Access Compliance Report

Public Rights-of-Way

(Curb Ramps)

Intersection ID: 12527	Main Street: E_7TH_ST	Cross Street: N_DAVIDSON_ST	Location: S
ADA ID: 8F5733BDD0AD	Ramp Type: Perpendicular Diagonal	Initial Pass/Fail: Fail	Overall Compliance: No
			Severity Score: 21.25

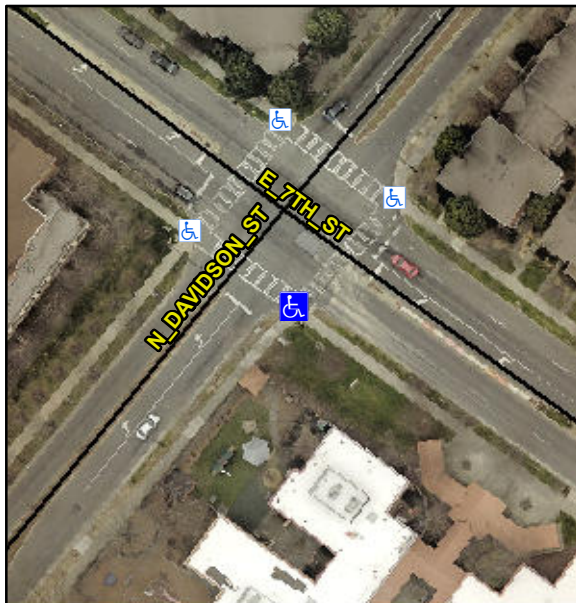
R304.5.1, R304.5.3

Compliance	Description	Data	Compliance	Description	Data
N/A	Ramp Length (in)	39.0	Yes	Ramp Slope (%)	5.1
No	Ramp Width (in)	45.0	No	Ramp XSlope (%)	6.3
N/A	Flare Type LT	N/A	N/A	Flare Type RT	N/A
N/A	Flare Slope LT (%)	N/A	N/A	Flare Slope RT (%)	N/A
N/A	Flare Traversable LT?	N/A	N/A	Flare Traversable RT?	N/A
N/A	Landing Length (in)	N/A	N/A	DWS Provided?	N/A
N/A	Landing Width (in)	N/A	N/A	DWS Contrast?	N/A
N/A	Landing Slope (%)	N/A	N/A	DWS Length (in)	N/A
N/A	Landing X Slope (%)	N/A	N/A	DWS Full Width?	N/A
N/A	Landing Curb? (Y/N)	N/A	N/A	DWS Offset (in)	N/A
N/A	Shared Landing?	N/A			
N/A	Gutter Ponding?	N/A	N/A	Gutter Slope (%)	N/A
N/A	Gutter Lip Ht (in)	N/A	N/A	Gutter X Slope (%)	N/A
N/A	Painted X Walk1?	Yes	N/A	Painted X Walk2?	Yes
	X Walk 1 Direction	To NE		X Walk 2 Direction	To NW
N/A	X Walk 1 Width (in)	110.5	N/A	X Walk 2 Width (in)	110.5
	X Walk 1 Slope (%)	1.5		X Walk 2 Slope (%)	6.6
	X Walk 1 X Slope (%)	6.4		X Walk 2 X Slope (%)	2.4

Remove & Replace Curb Ramp With Two New Directional Ramps or Equivalent.
